TECHNICAL BULLETIN
Bell Helicopter
A Textron Company

No. 407-08-84

MODEL AFFECTED: 407

SUBJECT: AFT CROSSTUBE ROCKER BEAM SUPPORTS
BHT P/N 400-052-006-101, 400-052-006-103 AND
AERONAUTICAL ACCESSORIES INC. (AAI)
SUPPORT P/N 407-729-101, MODIFICATION OF.

Figure 1: Landing gear rocker beam support, rework of.

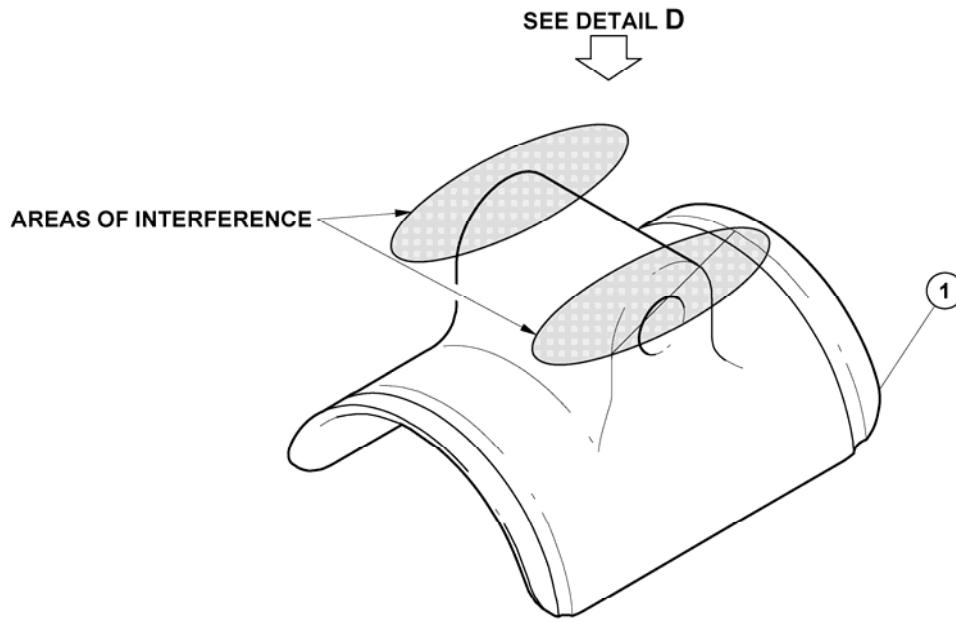
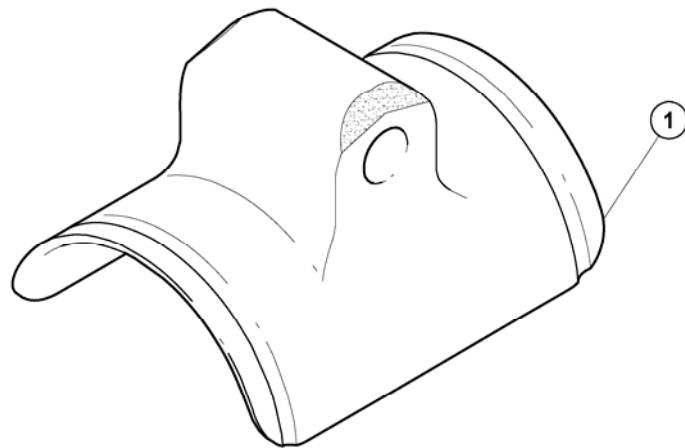
An improved aft crosstube rocker beam P/N 400-052-007-123 was recently introduced to the Bell 407 model landing gear installations. Subsequently, it was discovered that this improved rocker beam can have some interference fit with subject mating pivot supports. This improved beam assembly 407-052-007-123 is the current Production and Spare configuration now delivered for all landing gear configurations. This bulletin provides instructions to modify the subject rocker beam pivot supports to permit installation and free motion of this new rocker beam assembly. Rocker beam mating pivot support 407-729-103 is the current Production and Spare configuration that was introduced to fit with the new rocker beam 400-052-007-123 and does not require modification.

DETAIL B
SUPPORT BEFORE MODIFICATION

DETAIL C
SUPPORT AFTER MODIFICATION

6. (Ref. to Figure 3) Use a hand file and start removing material at the tip of the support (1) to obtain a shape as indicated in Detail C. Work the file at 45 degrees angles and in the orientation as seen in detail H and Section I-I until you reach the lines made earlier and you obtain the shape required.
7. Repeat step 6 for opposite side of the support (1).
8. After the shapes shown are obtained by hand filing method, use Aluminum Oxide abrasive paper, 320 grit or finer and sand each reworked surface to obtain a roughness of 125 RA (Roughness Average) maximum. Break all sharp edges by removing 0.015 inch (.381 mm) material by 45 degrees or by obtaining .15 Radius.

Figure 2: Landing gear rocker beam support, preparation of (sheet 1 of 4).

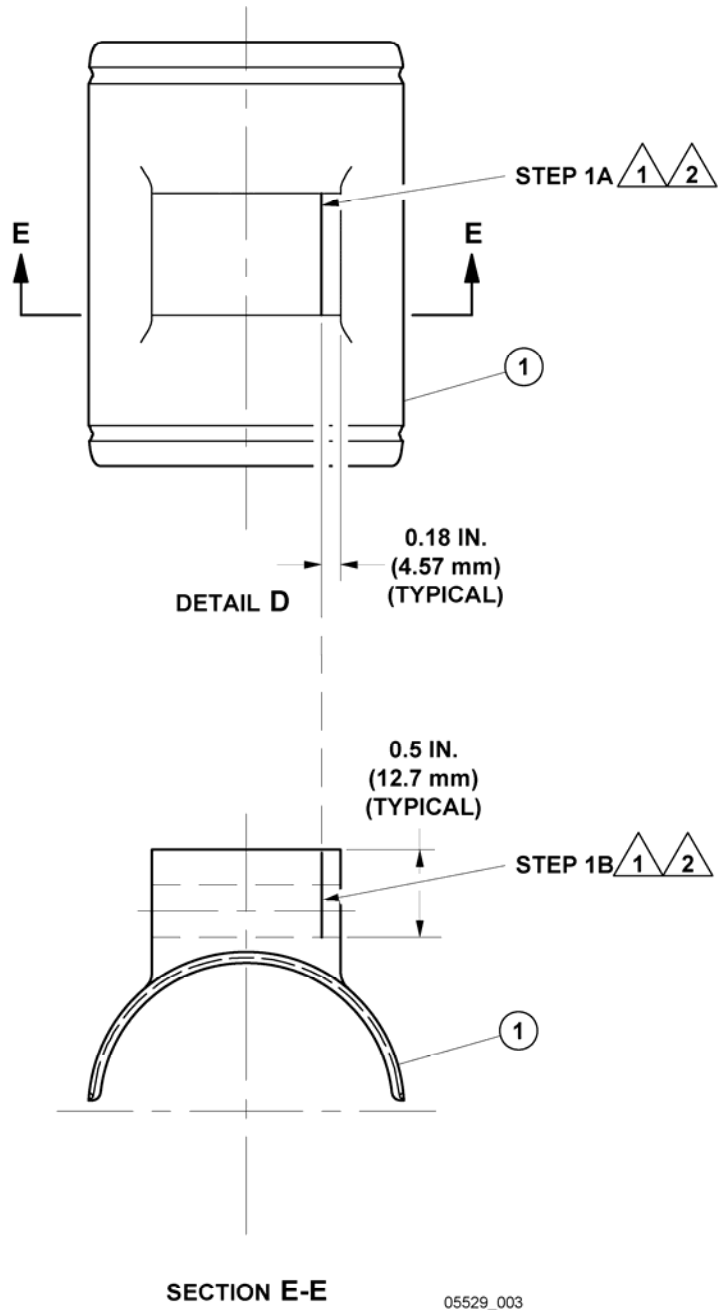
Step 1a: (Ref. Detail D). Looking down at the support (1), start drawing a straight line located at 0.18 inch (4.57 mm) from the edge on top of the support (1).

Step 1b: (Ref. Section E-E). Looking sideways at the support (1), run the line made in step 1a straight and down following external contour of the support (1) but parallel to the edge. Extend this line down .500 inch (12.7 mm) on each side of the bolt pivot axis.

DETAIL F

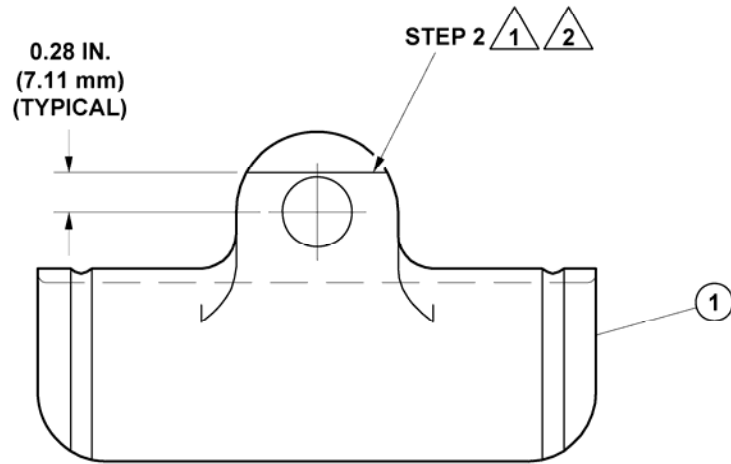
Step 2: (Ref. Detail F). Looking at the support, measure 0.280 inch (7.11 mm) from the center of the pivot hole and draw a lateral (horizontal) line on the machined face of the support (1), running from edge to edge.

Step 5: (Ref. Detail H). Join the marked location made in Step 4 to each tip of the line made in step 3 located at the edges of the machined face. These new lines should be at 15 degrees in reference to a plane passing through the center of the pivot hole as seen in Detail F.

DETAIL G

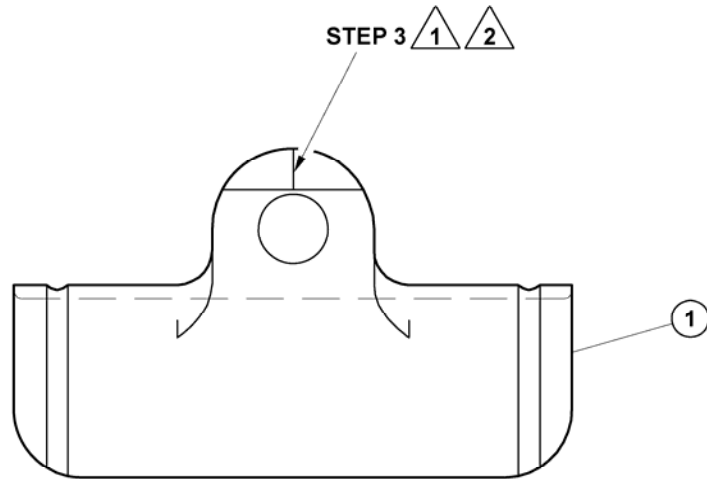
Step 3: (Ref. Detail G). From the center of the pivot hole in the support (1), draw a line extending vertically on the machined face of the support (1).

DETAIL H

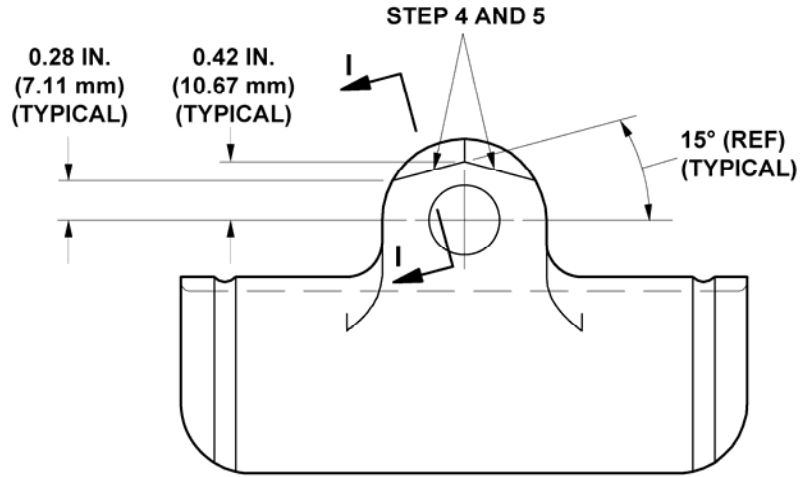
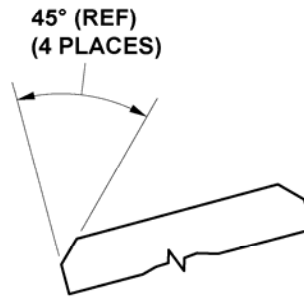
Step 4: (Ref. Detail H). Mark a location at 0.42 inch (10.67 mm) on each vertical line made in Step 3 measured from the center of the pivot hole.
